June 12, 1979
Project MSM-102A

Subject: Cotter Tailings Impoundment
Supplemental Questions from the State
on Existing Tailings Transfer Proposal

PROJECT NO.	817
DATE	DECEMBER 1958
BY	
CHECKED BY	
DESIGNED BY	
APPROVED BY	
TITLE	COTTER URANIUM TAILINGS IMPONDMENT TAILINGS DRAINAGE PLAN

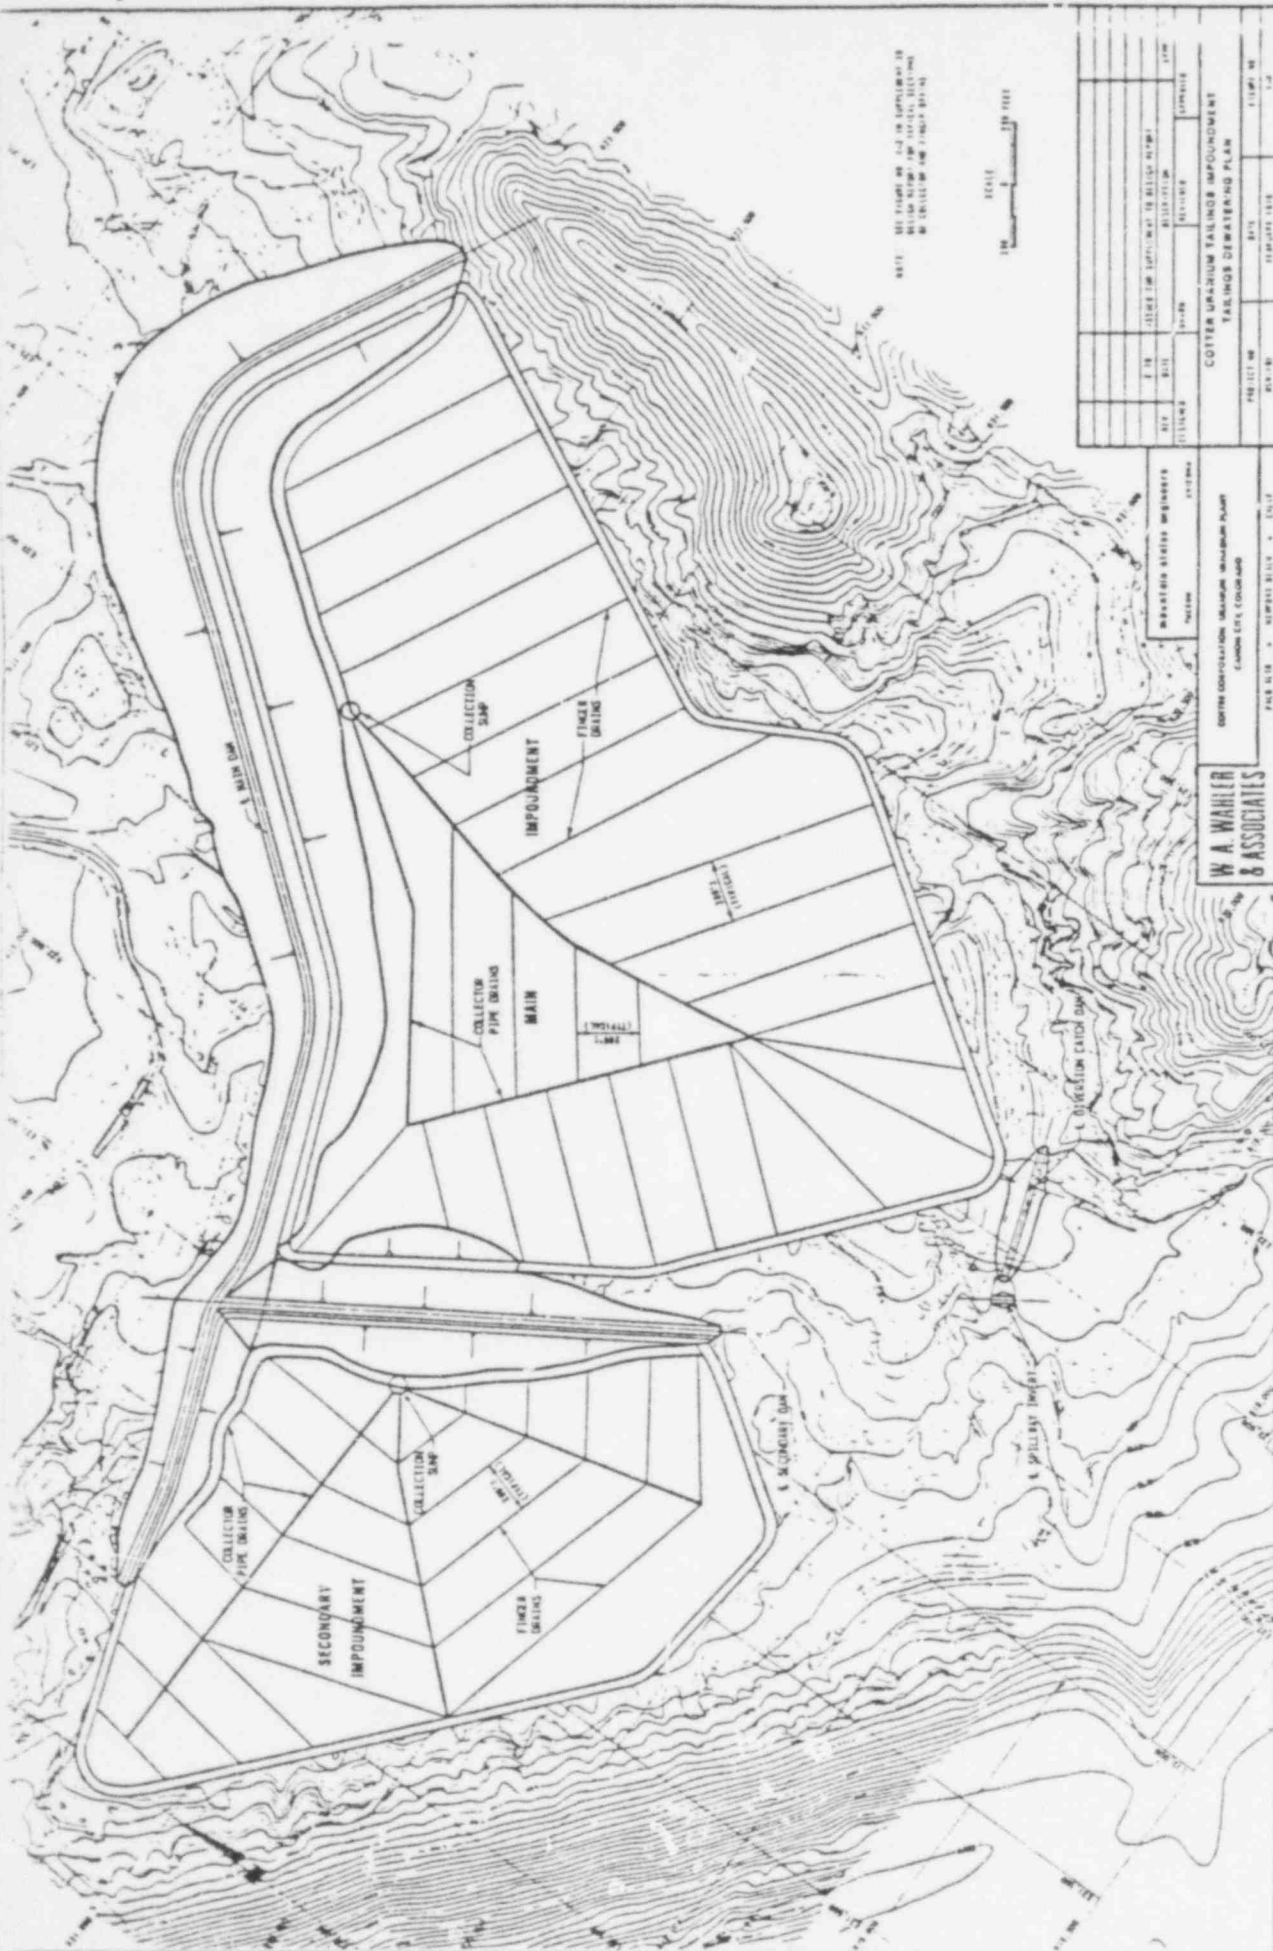
1. How would the existing tailings be transferred say after two to three years of operations in the Main Impoundment?
2. With the tailings dewatering drains on top of the lining) operational, what keeps the acid water in the Main Impoundment from mixing with the alkaline water in the Secondary Impoundment?
3. In reference to John Logan's letter of June 5, 1979, additional clarification is requested concerning the third paragraph of Page 3. This deals with the delay in the implementation of the Lincoln Park criteria until the remedial action recommended in our October 1978 report has been fully implemented.

2. As shown on attached Figure I-4, the tailings dewatering drains in the Main and Secondary Impoundments are completely separate and independent of each other. The drains do not run under the Secondary Dam.
3. The basic intent contained on Page 3, paragraph 3 of John Logan's letter dated June 5, 1979 was to allow the recommended remedial action to be accomplished before we started applying the monitoring criteria in Lincoln Park. Basically, we are saying that lets pump out and clean the SCS reservoir and abandon all the existing tailings ponds (except 1 and 6) before we apply criteria to tell us if Ponds 1 and 6 need to be transferred. It is not intended that new baseline data be established in Lincoln Park.
